A66 Northern Trans-Pennine Project

7.24 Applicant's Responses to the Examining Authority's Written Questions

**7.24 APPLICANT'S RESPONSES TO THE EXAMINING AUTHORITY'S
WRITTEN QUESTIONS**

Deadline:	Deadline 4
Planning Inspectorate Scheme Reference	TR010062
Application Document Reference	NH/EX/7.24
Author:	A66 Northern Trans-Pennine Project, Project Team, National Highways

Order limits

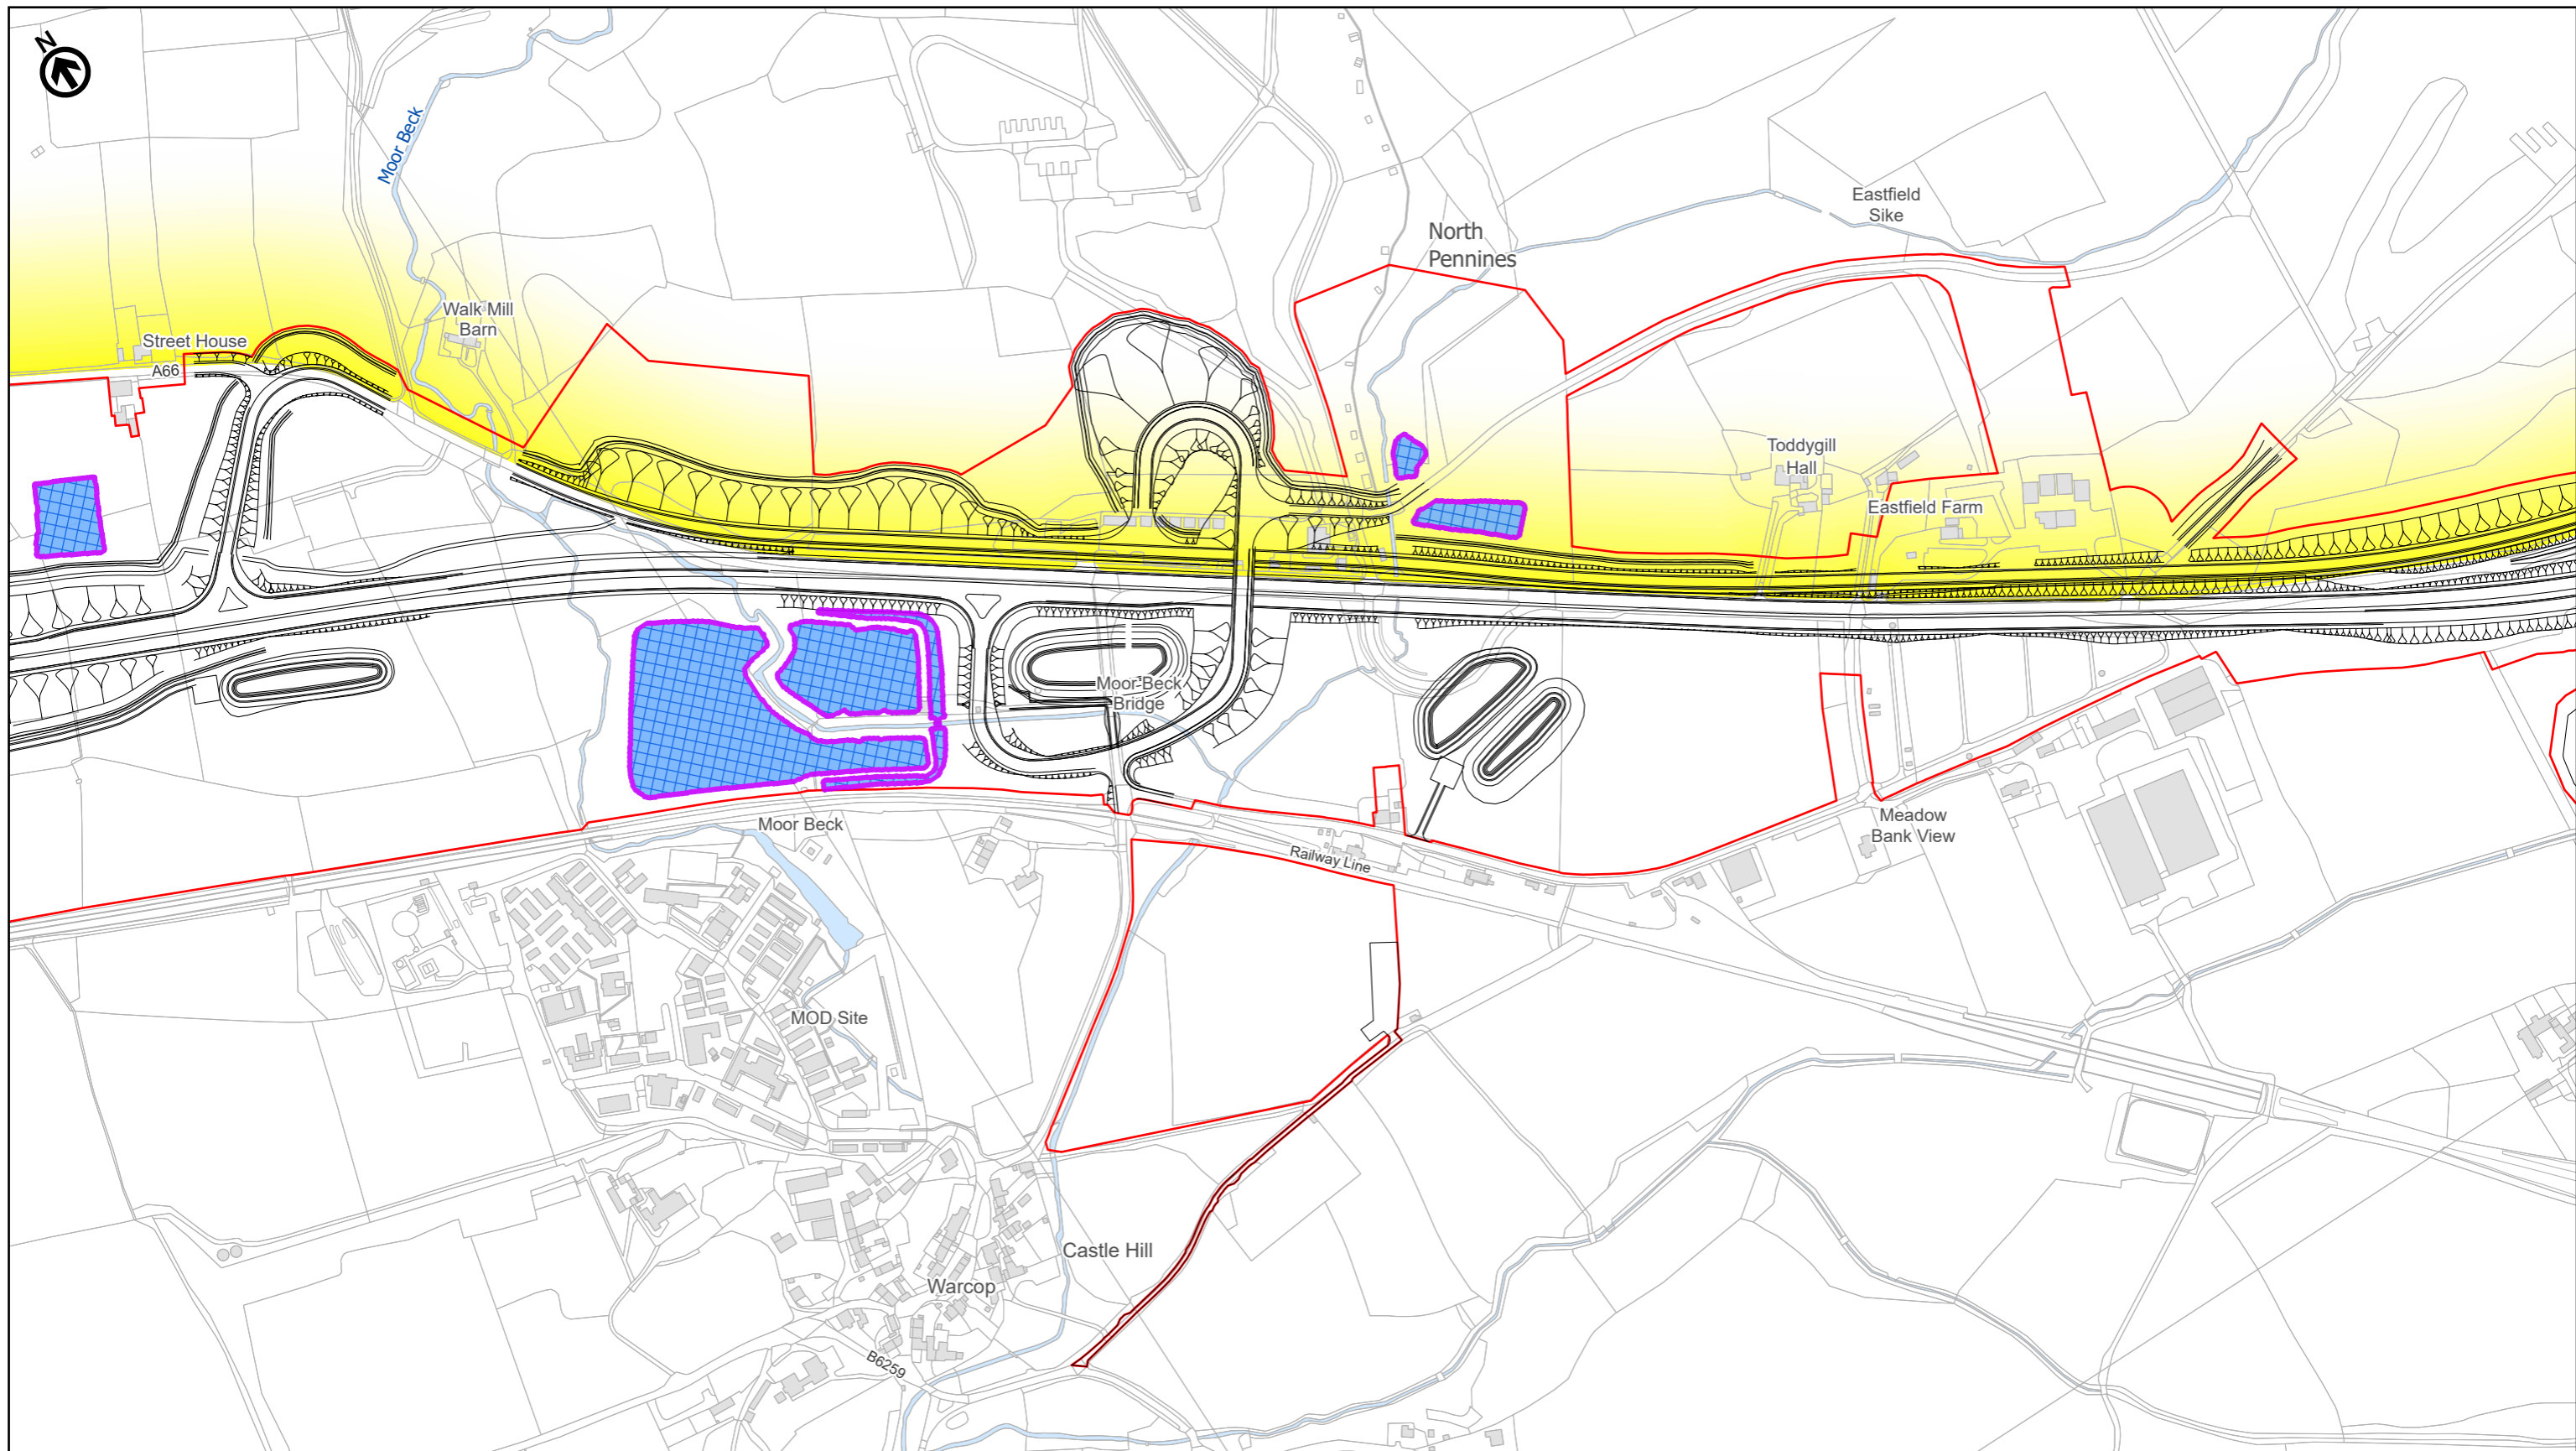
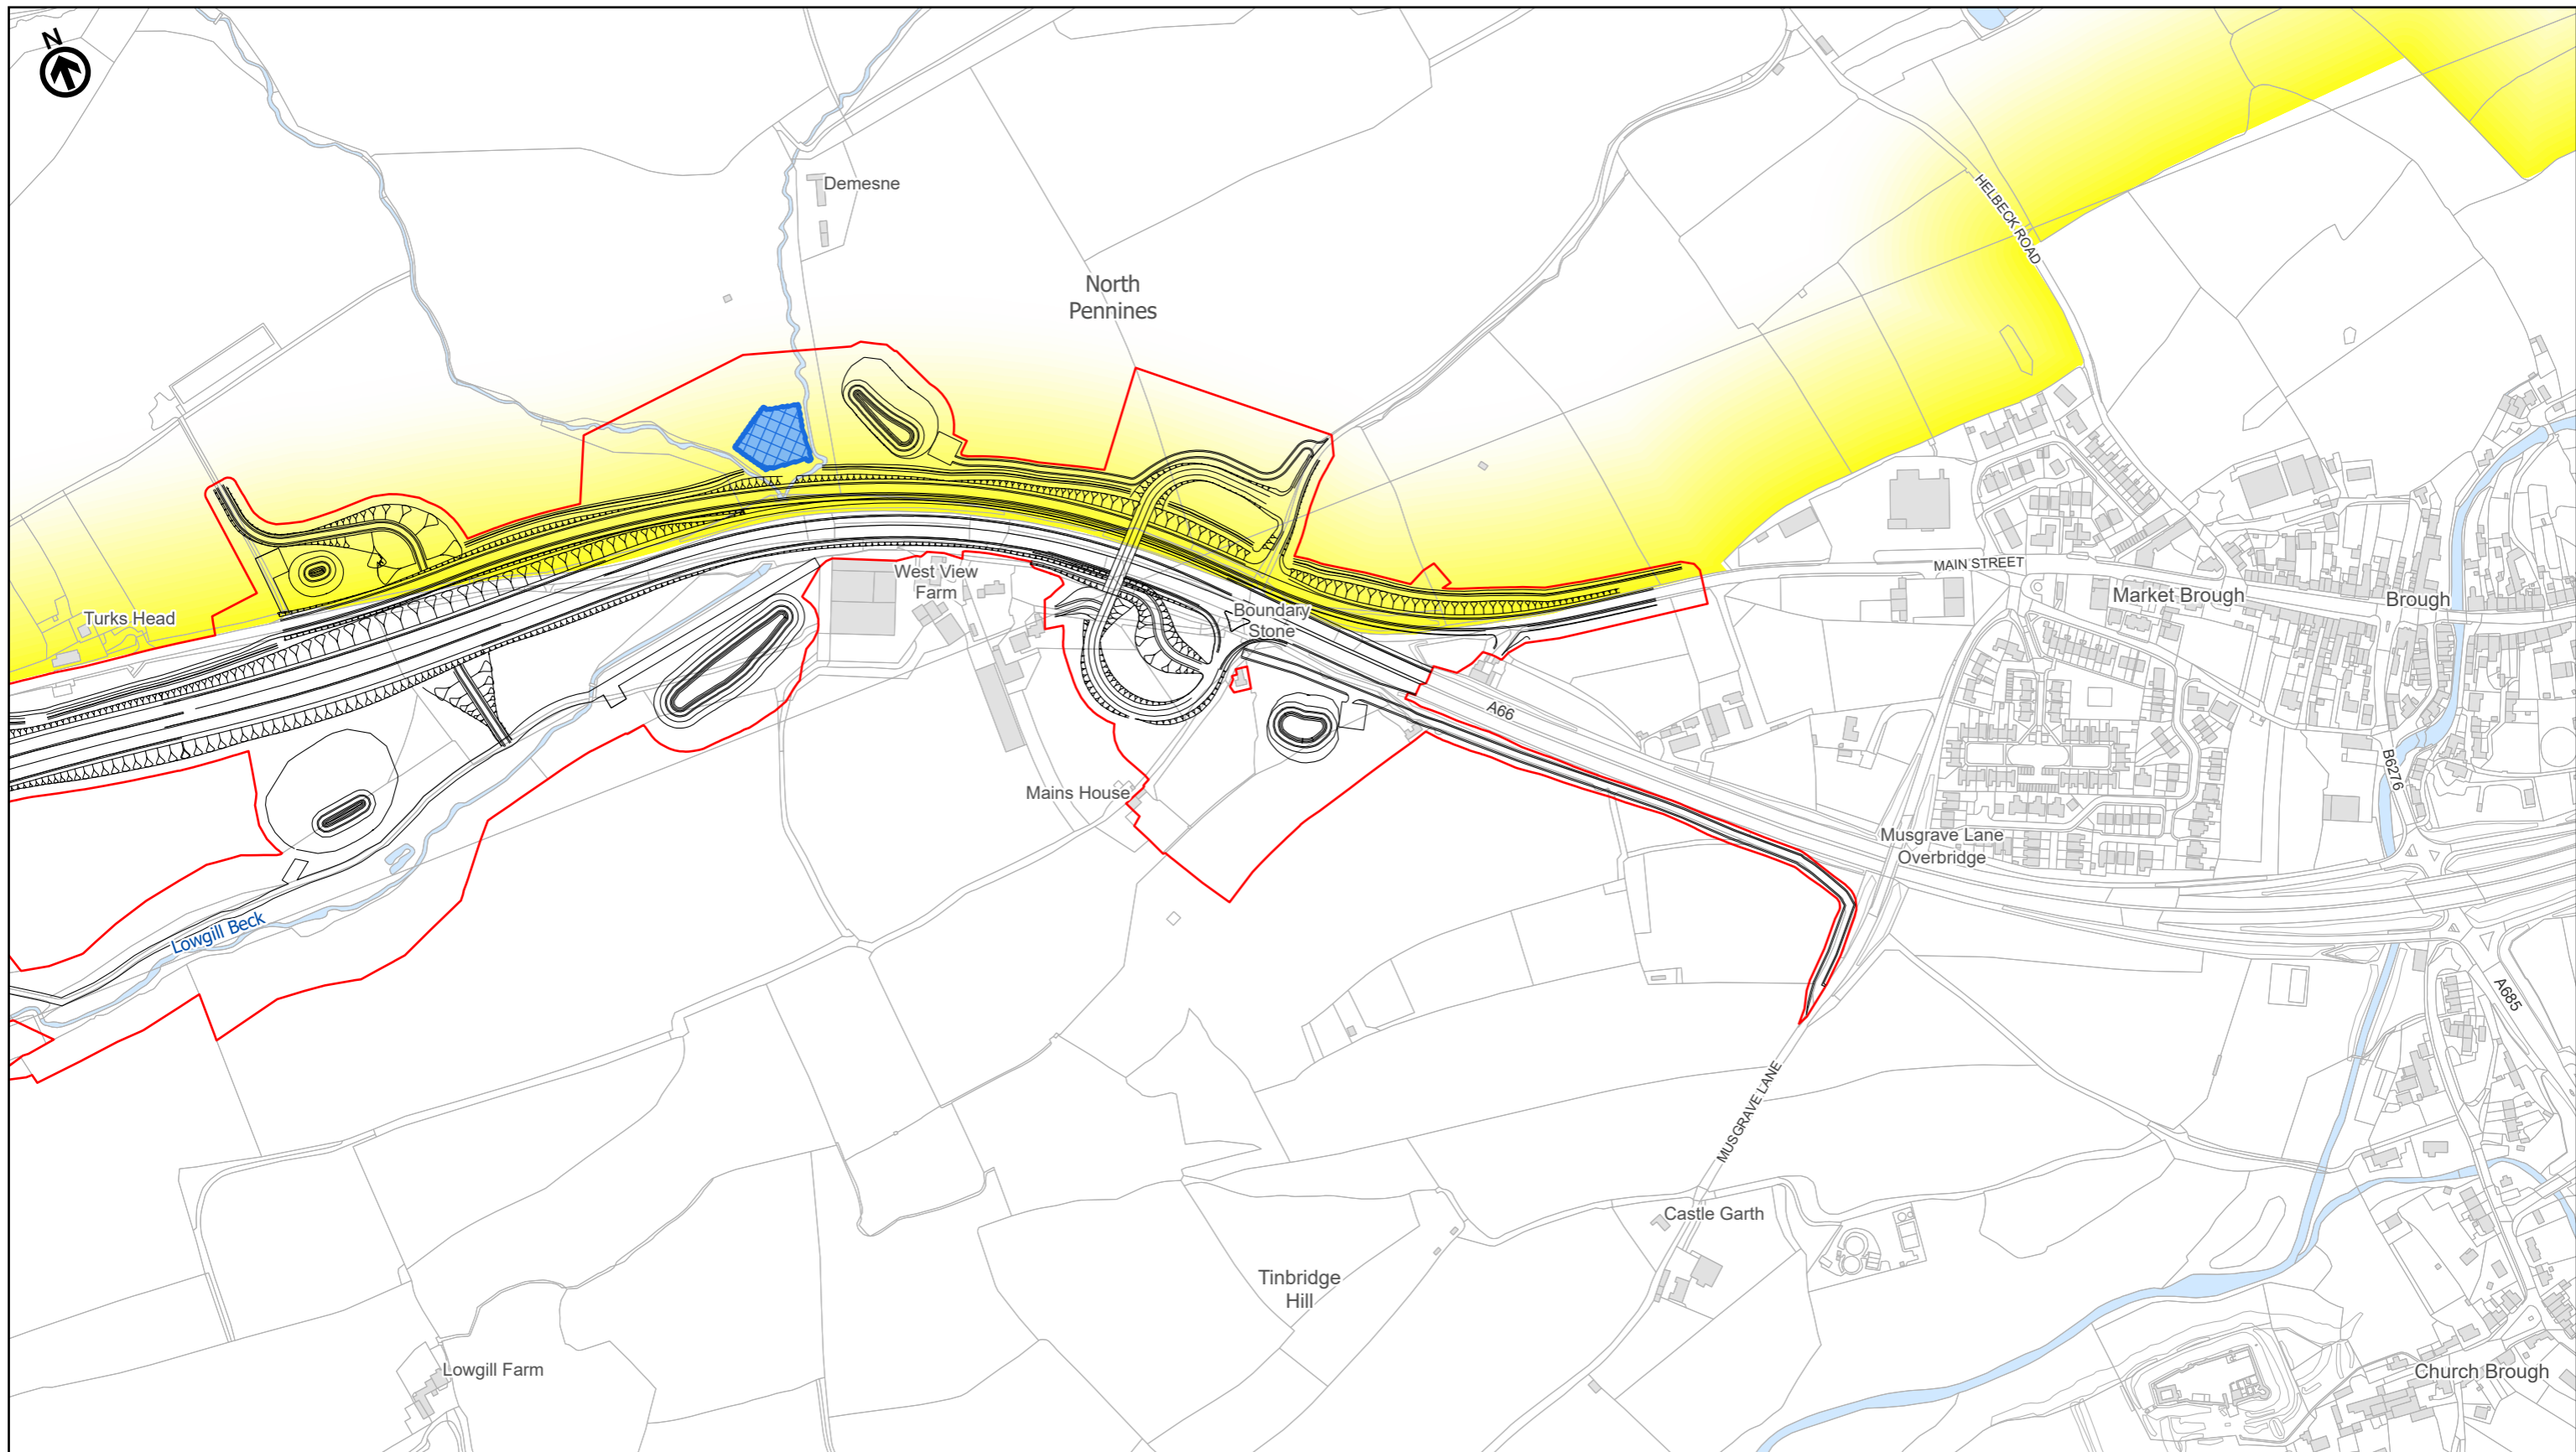
FDW 1.9	Preliminary Drainage Design	The Applicant	For each scheme, provide a set of plans to identify 'level for level' compensation and 'indirect storage (or volume for volume compensation)' areas [APP-221, para 14.2.5.132 and Plate 4]. This set of plans should be in a similar format to the environmental mitigation maps [APP-041] and could be added to the mitigation maps if the Applicant considers this to be a better way of comprehensively	<p>Flood compensation areas have been designed for the Main Rivers in Scheme 4,5 and 6. A separate set of plans has been prepared (see Appendix B of this document) to highlight the compensation areas proposed for these schemes. The plans are based on the Environmental Mitigation plan style and sheet numbering system. For clarity, only sheets that include flood compensation areas have been provided.</p> <p>The location and shape of the mitigation measures shown on the plans provided demonstrate how they can be incorporated into the detailed design of the Project, but are subject to re-location and/or further refinement at the detailed design stage, in accordance</p>

Ref Number	Subject	Response by	Question	Applicant's Response
			identifying the future purposes of land within the Order limits in terms of any Compulsory Acquisition of land and rights.	with the provisions of the Environmental Management Plan (Application Document 2.7, [APP-019] as updated) and the Project Design Principles (Application Document 5.11, [APP-302] as updated), see in particular measures D-RDWE-12 (which requires consultation with the statutory bodies that possess functions relevant to the control of flood risk) and D-RDWE-13 (which requires further hydro morphology and geomorphology assessments to determine flood compensation storage requirements) and D-RDWE-14 (which makes provision for further flow modelling in relation to the works associated with Warcop Junction). Subject to detailed design carried out in accordance with the Environmental Management Plan and Project Design Principles, other flood compensation areas may be required in other areas of those Schemes or in respect of other Schemes and so, in relation to land requirements the plans contained in Appendix B are not definitive..
